Title: Northstar Accelerator Based Mo99 Production Facility Design Support
LANL FY20 Quarters 1 and 2 Facility Design Support Report

Northstar Accelerator Based Mo99 Production Facility Design Support

LANL FY20 Quarters 1 and 2 Facility Design Support Report

Figure 2. The current target design, also comprised of individual disk holders stacked in a body. In this design the U-shaped holder part can slide outward to open up the coolant gap and release the disks.

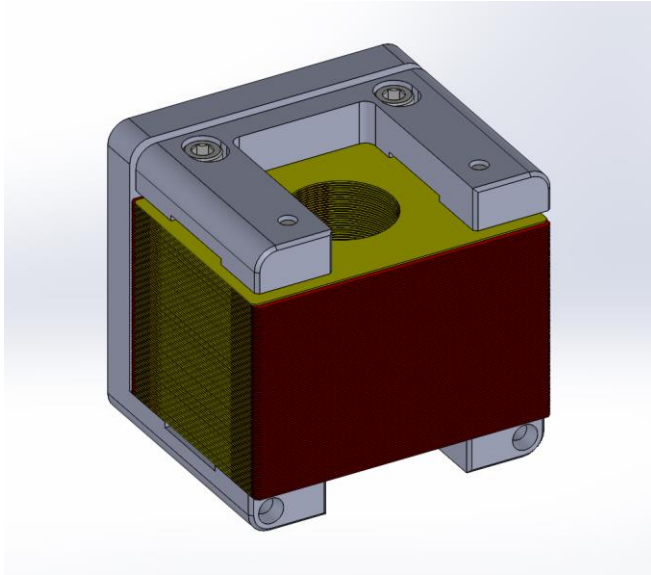
Currently, the plan is to proceed with a design developed by MBraun/Springs which incorporated a separation motion that in principle allows the disk to drop out of the holder while leaving the steel holder parts within the holder body. This is shown in Figure 2. As shown in the figure, this concept requires a rather thick yoke piece. The result is that the window is now some distance from the target housing. This has serious impact on several aspects of the design. First, there is a high heat load in the yoke itself and at present means to remove that heat. Second, the window is cantilevered off of the housing, and then the cantilevered cylindrical part is bolted to the housing. There is 5 kW thermal in the flanges on each window (10 kW total) with no cooling. These are radical and very high risk changes to the baseline design. Thermal cycling of the flanges holding the window will certainly lead to helium leaks into the beamline. The wider target holder configuration also impacts the diameter of the target insertion pipe, increasing weight and adding complexity to the handling of the larger part. Radiation streaming control is also more difficult.

Figure 8. Current conception of the local target shielding, contractor design.

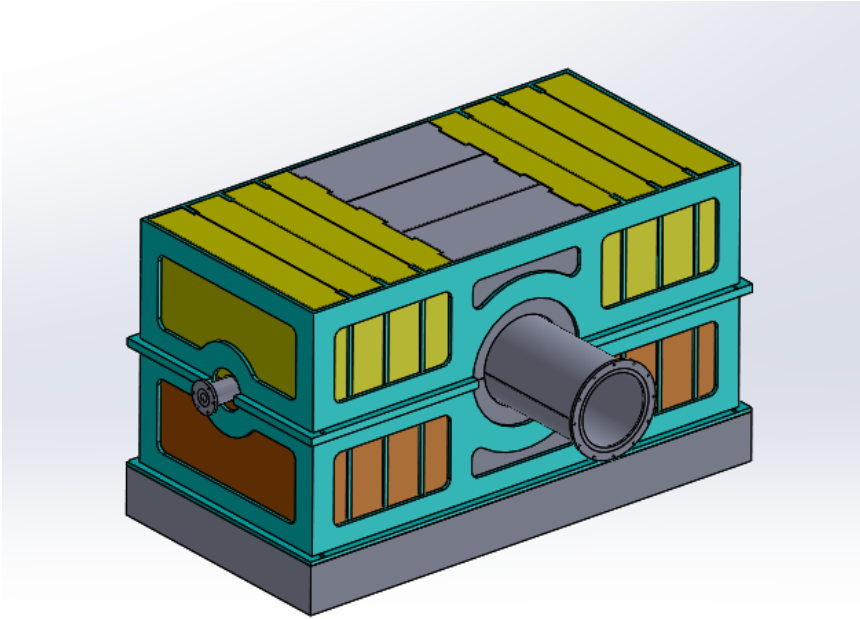
LANL has advised to not interlock the boxes. Radiation shine paths perpendicular to the beam are of secondary importance, and the narrow gap between boxes can be filled with lead or steel wool or matting.

More important however, is that the large number of boxes, and the vertical stacking, makes the water cooling rather complex. LANL suggestion is to install larger boxes with a flow distribution baffle at the bottom, then place steel plates vertically, with gaps between for cooling. Water would flow from bottom to top, also improving the removal of any gases generated by radiolysis. This would introduce radiation streaming paths normal to the beam. This could be accommodated, if necessary, by additional bulk shielding at the wall.

Figure 9. Cross section view of the target, as currently configured, with window bolted on to the housing.

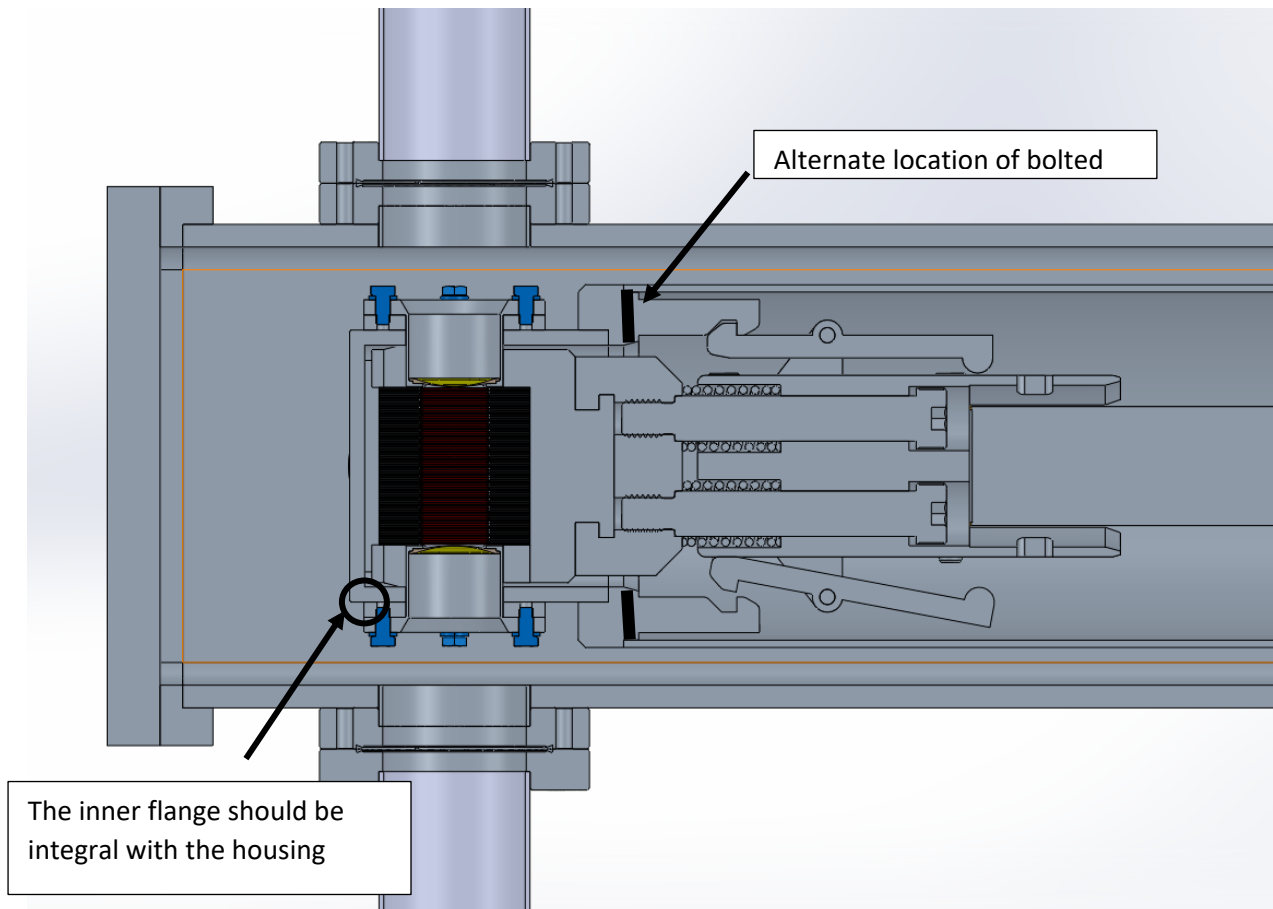
Figure 9 shows a cross section view of the target, with beam pips entering from the top and bottom. The current design has the windows screwed to the housing rather than welded. This will be difficult or impossible to adequately cool. Thermal cycling in this region will loosen the bolts over time. The windows should be welded to the housing and the bolted joint moved away from the high beam energy region directly in line with the target. If the bolted on window remains the preferred solution, the inner flange piece, currently envisioned as welded on, should be a machined feature of the housing, significantly improving thermal contact and facilitating cooling. As stated above, there is a very high heat load in the yoke and the target flanges that as yet has no cooling

Also in Figure 9, the target insertion mechanism remains in close proximity to the target during irradiation. Also, the containment pipe is in vacuum. Helium is flowing through the target and therefor fills the target insertion pipe. Some small fraction of the total helium flow should be directed down the target insertion pipe for cooling of these components.

Figure 10. Cross section view of the target through the helium supply route.

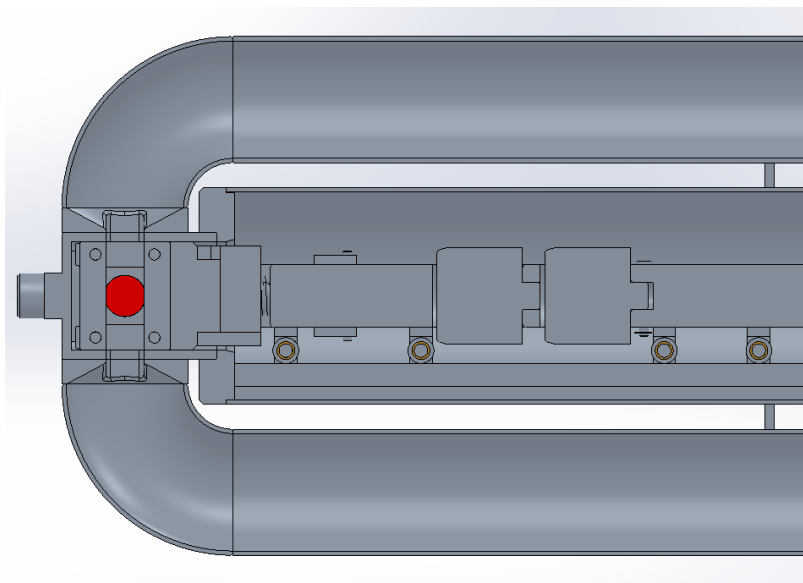
The target cross section view through the helium cooling lines, as currently conceived, is shown in Figure 10. The primary concern here is the rapid transition from round pipe to the rectangular flow channel necessary for flow through the target. This will result in unnecessary pressure drop, and a very turbulent flow entering the target, with regions of flow separation and recirculation. The recommendation is to extend the rectangular section of pipe around the bend and to make a smoother transition from the round to rectangular. Also, the helium pipe diameter has been increased from 2" to

3". While this reduces pressure drop along the long run from and back to the blower, it requires a larger target insertion pipe and requires more difficult or space consuming radiation shine path reduction.

Figure 11. Improved design of the helium channel entrance to and exit from the target.

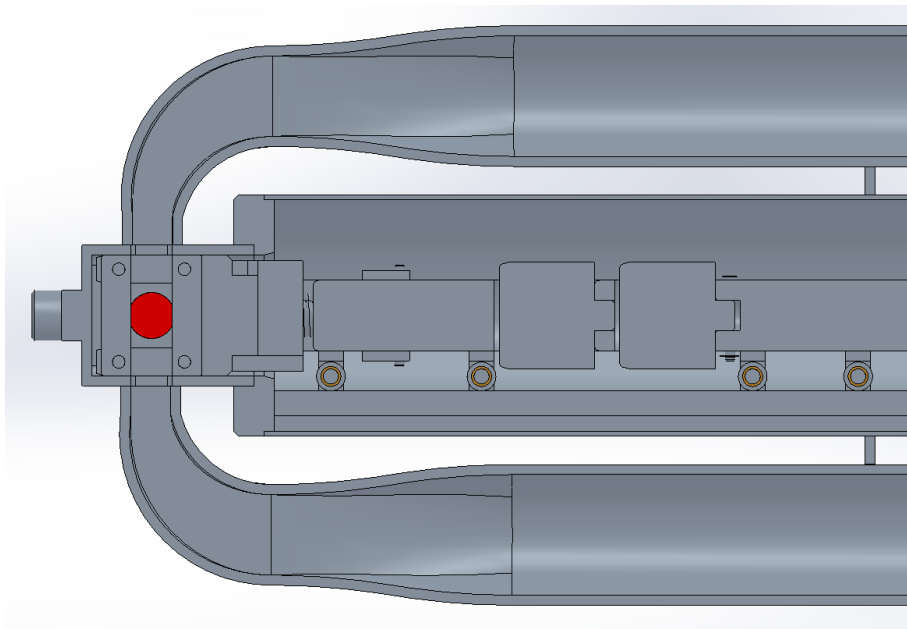
Northstar proposed a variation on the rectangular elbow that includes a gradual transition to the round pipe. This is shown in Figure 11. These variations have so far not been incorporated into the design.
